SERVICE BULLETIN

REPLACEMENT OF THE PROPELLER GEARBOX FOR SOME ROTAX® ENGINES TYPE 912/914 (SERIES)

SB-912-056

SB-914-038

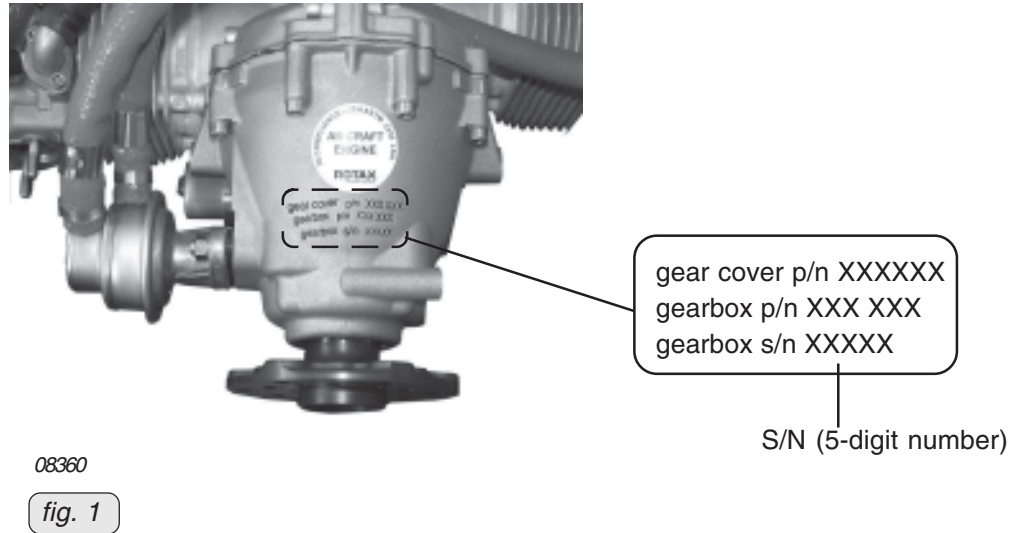
- ◆ **NOTE:** The relevant serial number of the gearbox is visible on the gearbox housing (see fig.1).
